Minutes – East Kildonan-Transcona Community Committee – November 17, 2015

Item No. 3 Subdivision and Rezoning – 1914 Henderson Highway (North Kildonan Ward) File DASZ 17/2015 [c/r SPA 4/2015 & DAV 130129/2015D]

Title: DASZ 17/2015, 1914 Henderson Highway

Issue: application for approval of a proposed plan of subdivision and rezoning to create one lot and widen the Henderson Highway Right-of-Way and to rezone the proposed lot from "R1-E" Residential Single-Family Estate to "RMF-M" Residential Multi-Family Medium

Figure 3 Existing Lots and Existing Zoning **North↑**

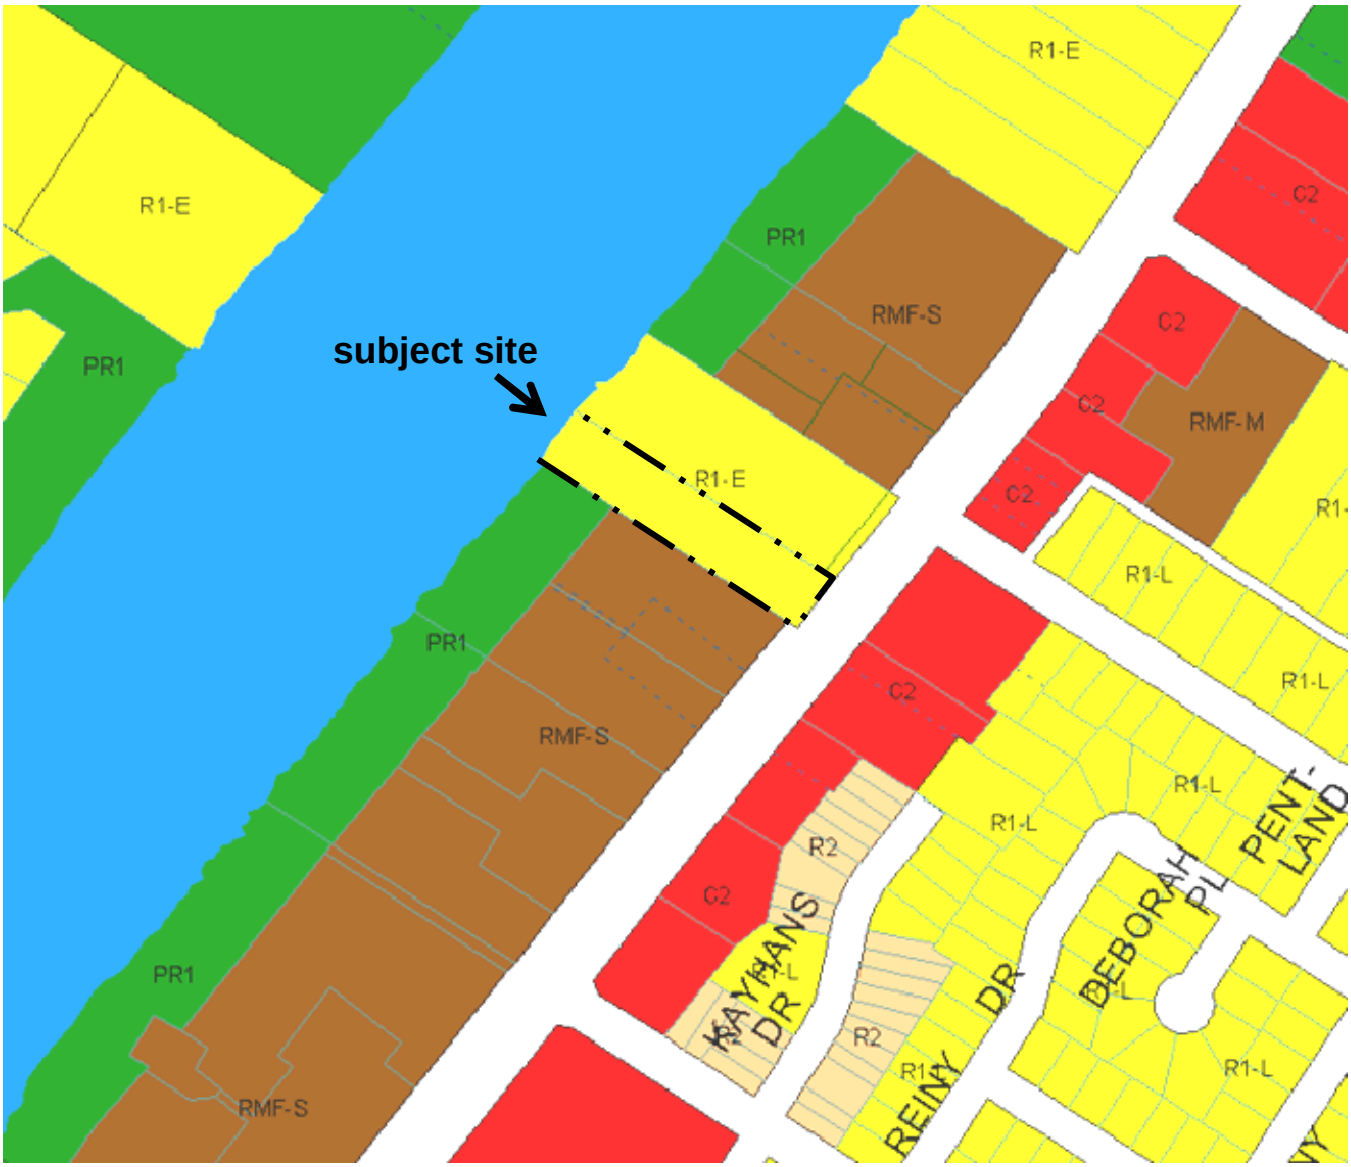
In addition, the aforementioned modification to create a public reserve zoned "PR-1" along the riverbank would be consistent with other public reserves along the east bank, as shown in Figure 3.
